10/729,197
December 27th, 2004
Reply to Office Action of 09/27/2004

Remarks

This amendment is in response to the September 27th, 2004 Office Action. Filed herewith and incorporated to this amendment is a 132 affidavit from the Maurice Jenkins, who is the first listed inventor in prior art Jenkins '718. Applicant respectfully traverses Examiner's rejections of claims 1-20 in light of the above amendments and the following remarks:

FIG. 1

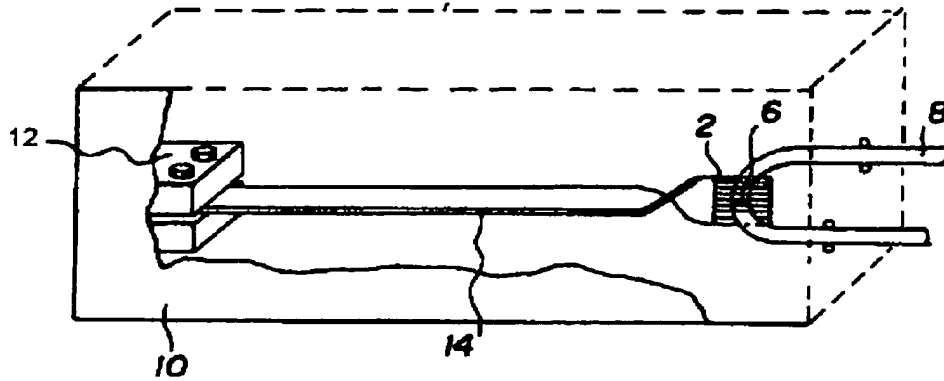
In regards to a prior art label on figure 4, this has been added.

← "PRIOR ART"
ADDED
